Value Engineering Study Report

**Georgia Department of Transportation
NHS00-0000-00(763) _ P.I. No. 0000763
I-75 from Lowndes County line to SR 37
Phase II
Cook County**

RE: Submittal of the final Value Engineering Report
NHS00-0000-00(763) – P.I. No. 0000763
I-75 from Lowndes County line to SR 37 – Phase II
Cook County

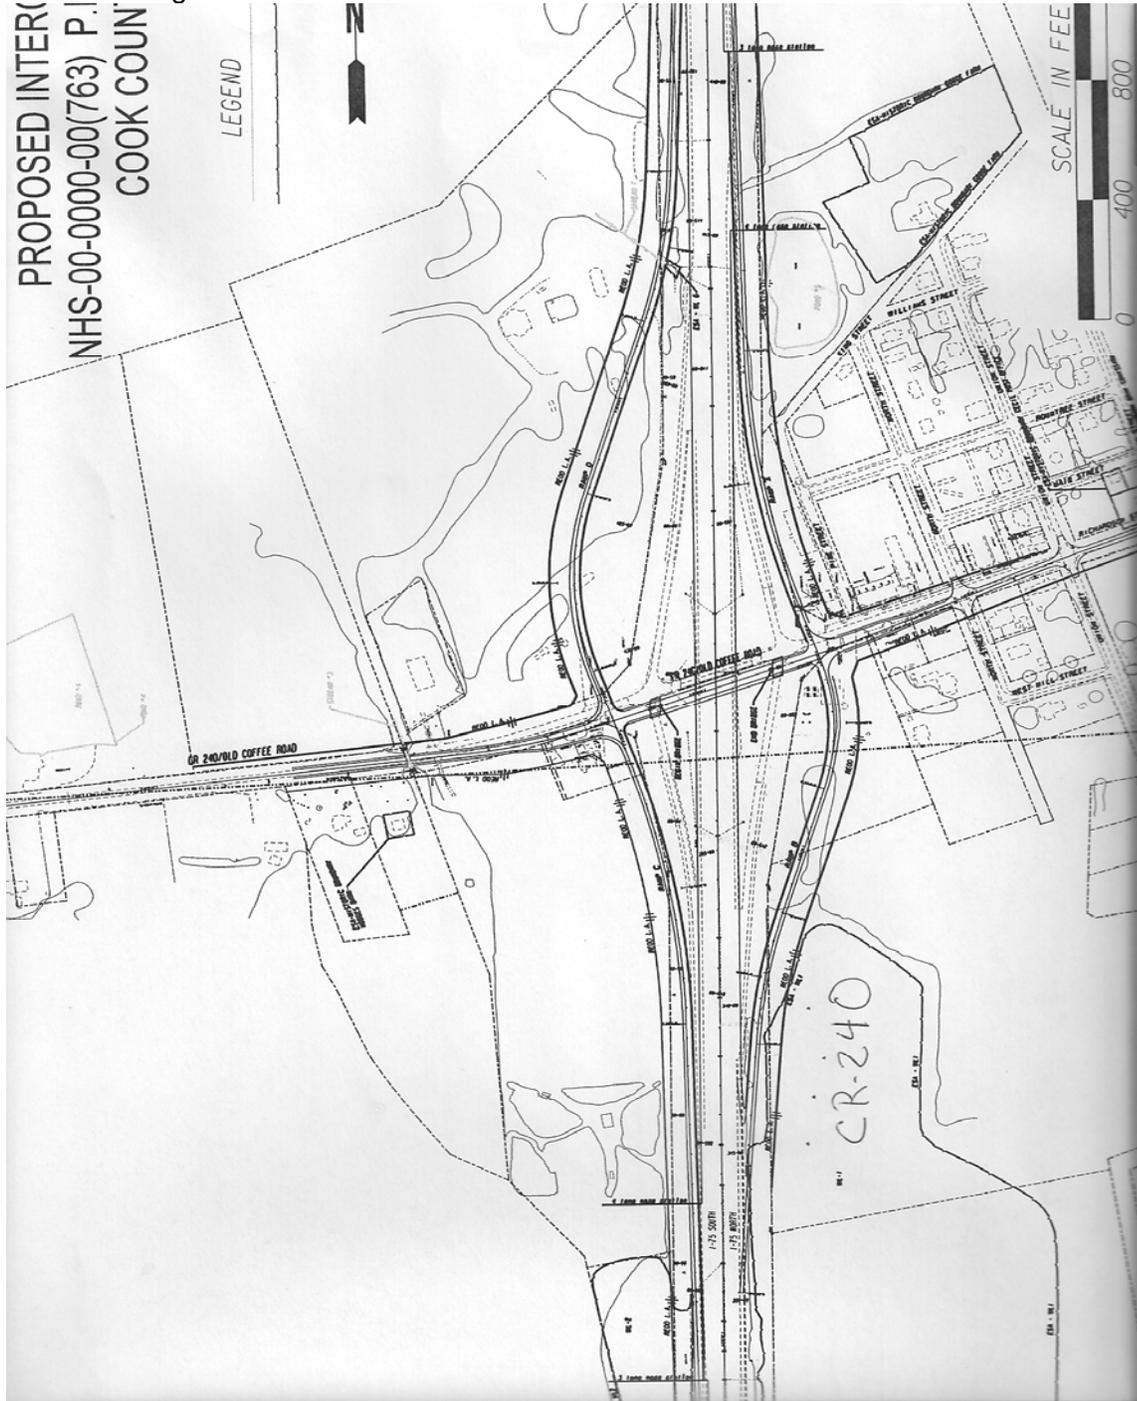
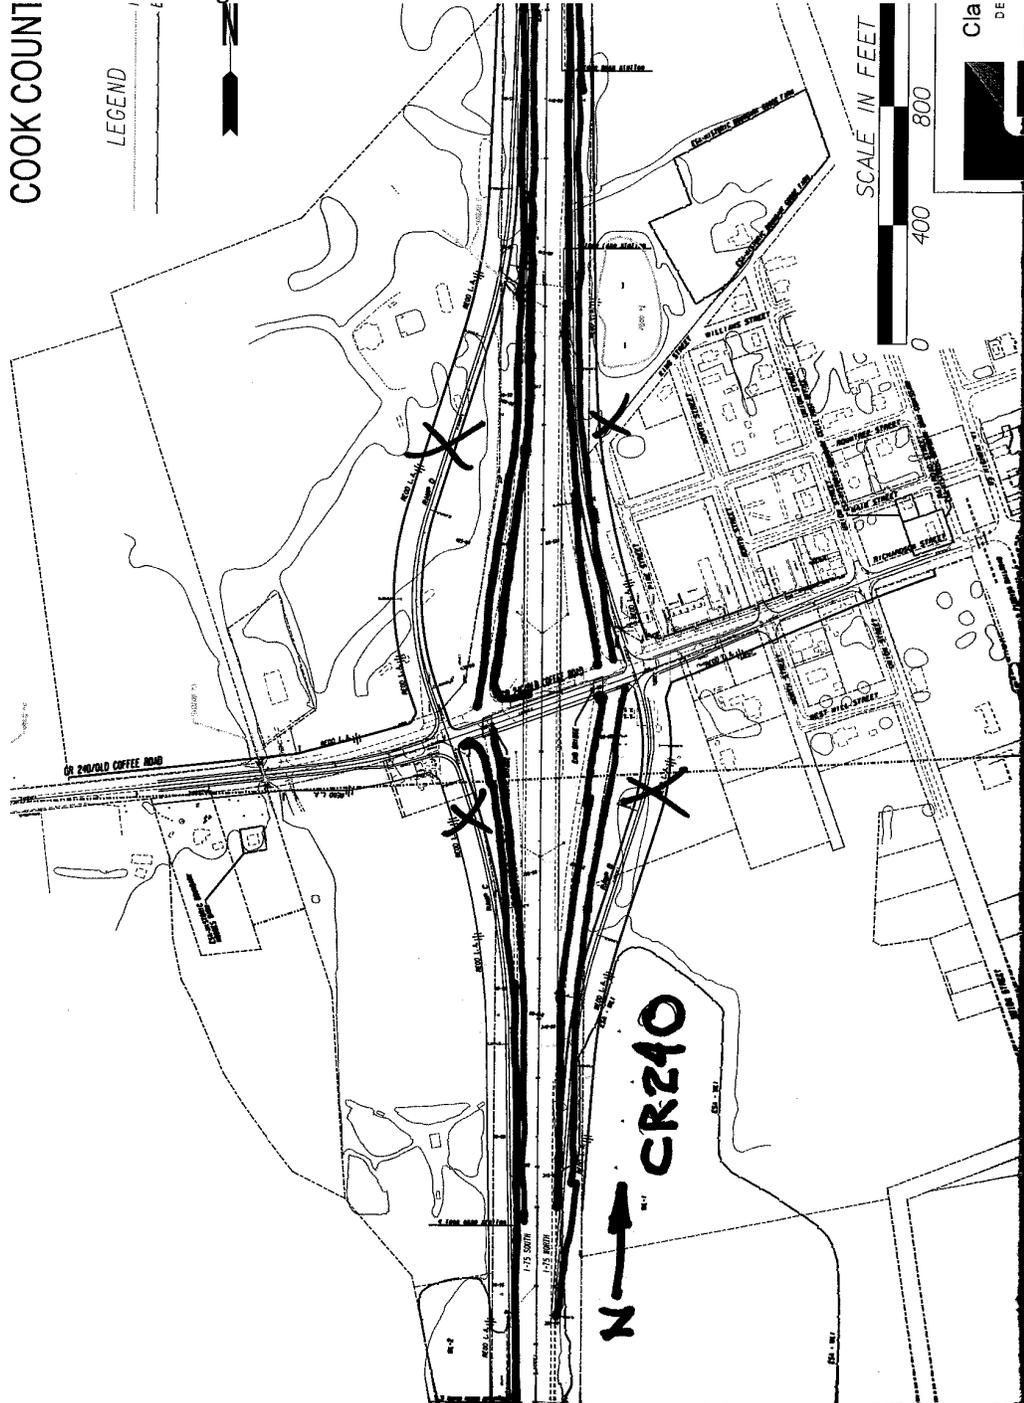
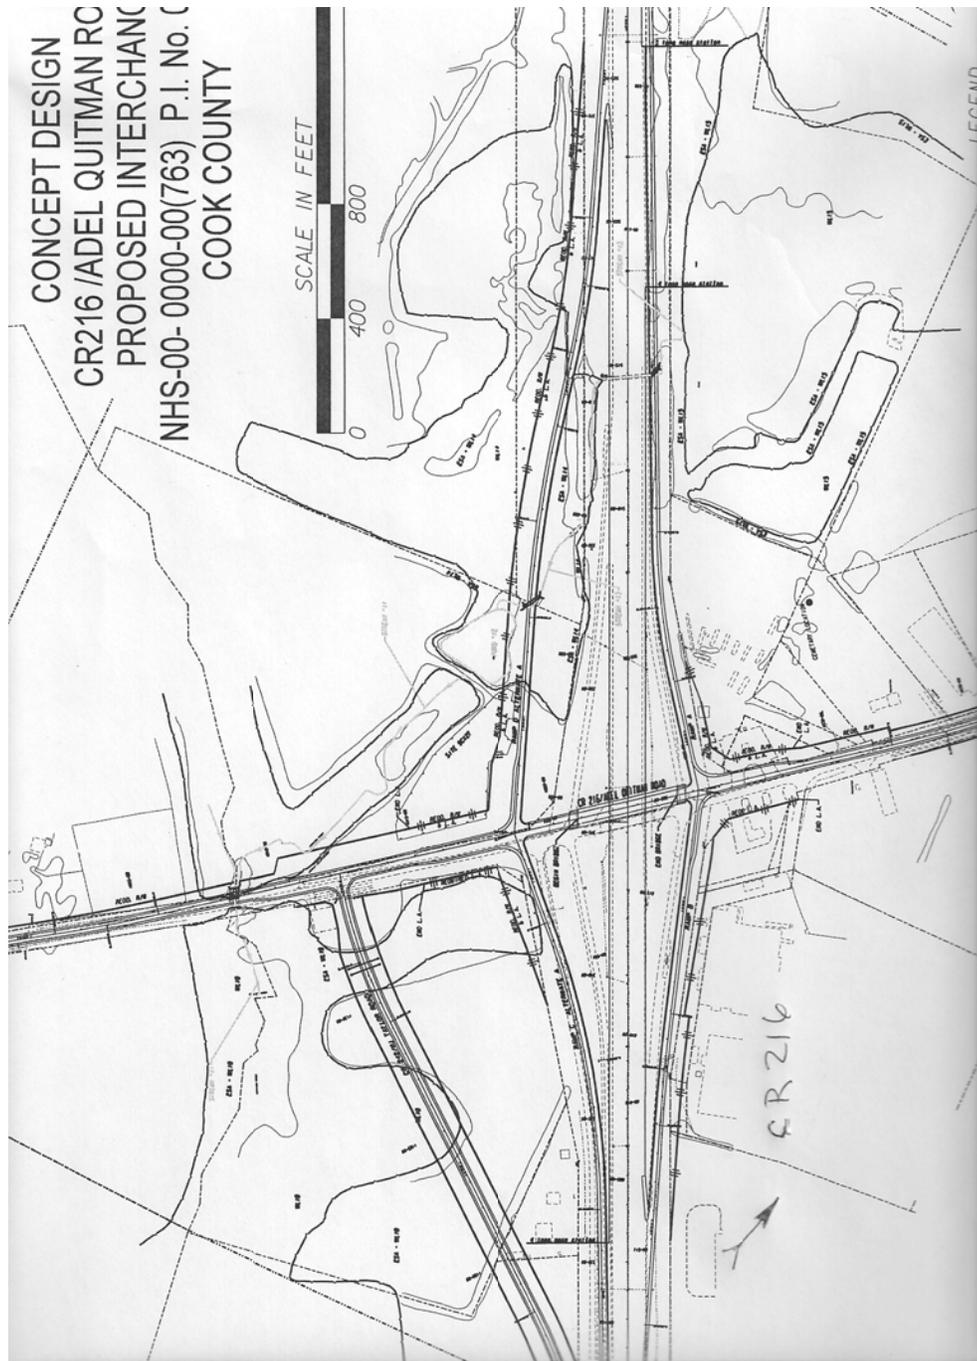
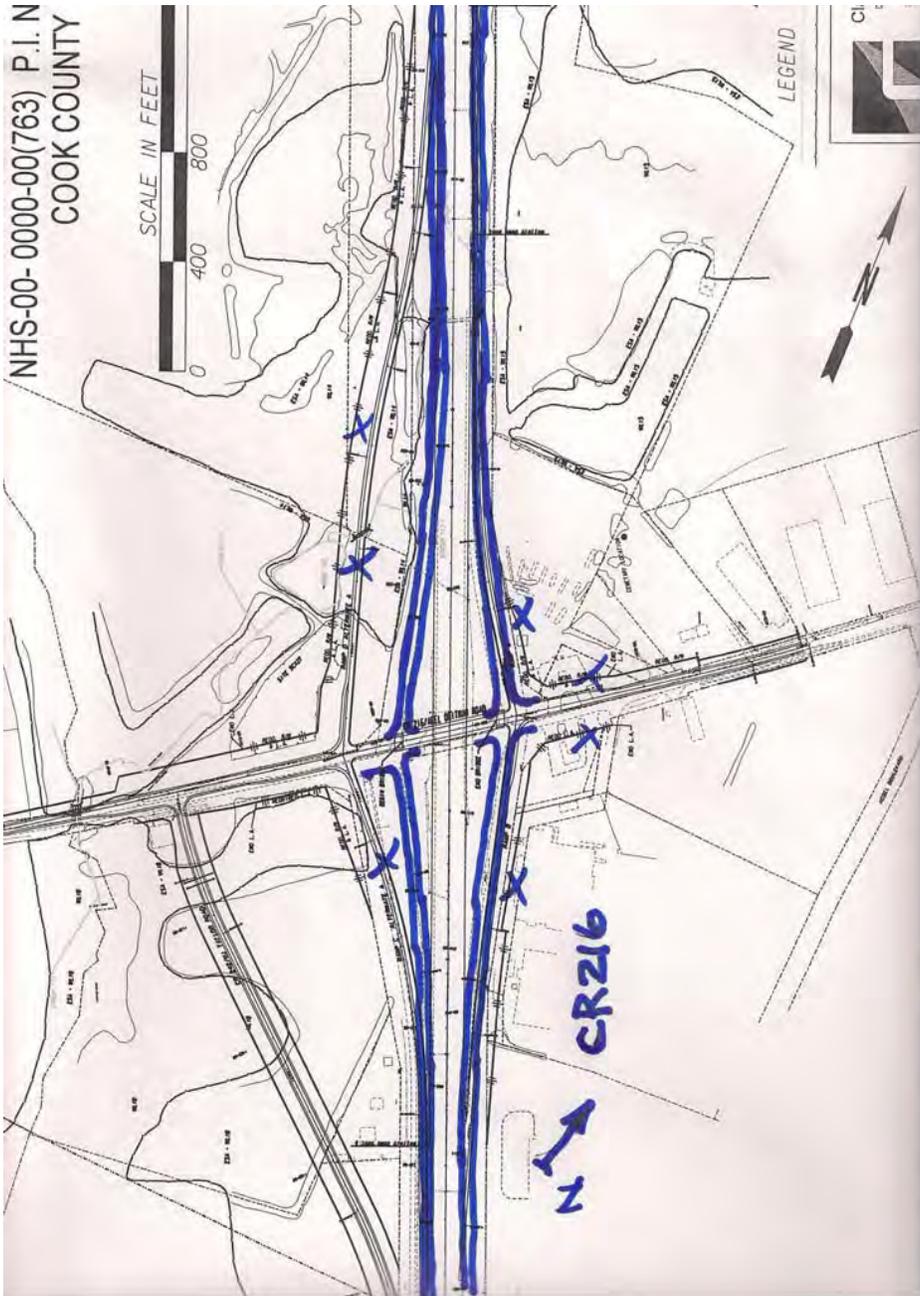
PROJECT:	Georgia Department of Transportation NHS00-0000-00(763) – P.I. No. 0000763 I-75 from Lowndes County line to SR 37 – Phase II Cook County	ALTERNATIVE NO.:	RD-13
DESCRIPTION:	Build a tight urban diamond at both interchanges	SHEET NO.:	1 of 8

ORIGINAL DESIGN
CR216 /ADEL QUITMAN ROAD

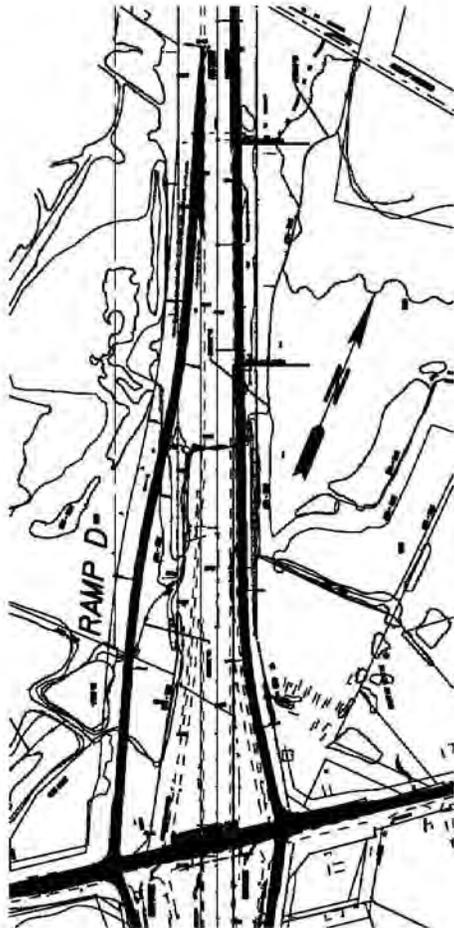
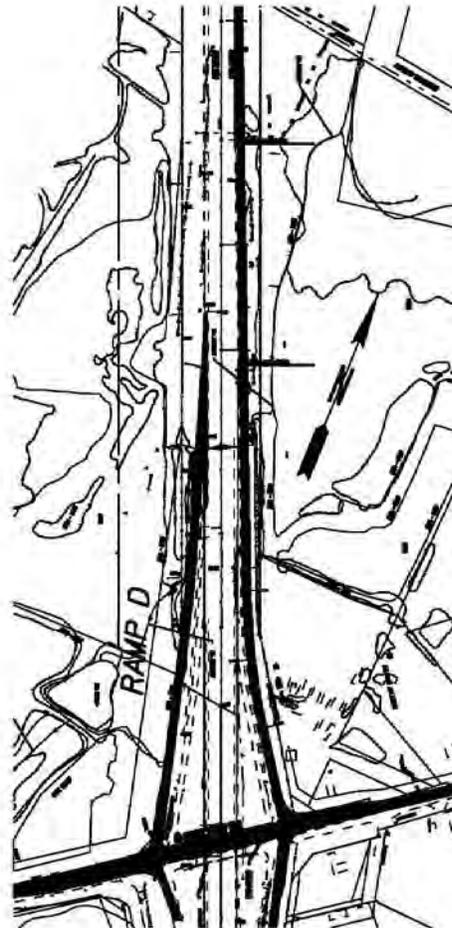
PROJECT:	Georgia Department of Transportation NHS00-0000-00(763) – P.I. No. 0000763 I-75 from Lowndes County line to SR 37 – Phase II Cook County	ALTERNATIVE NO.:	RD-14
DESCRIPTION:	Re-align CR-216 Ramp ‘D’ and relocate longitudinal stream	SHEET NO.:	1 of 5
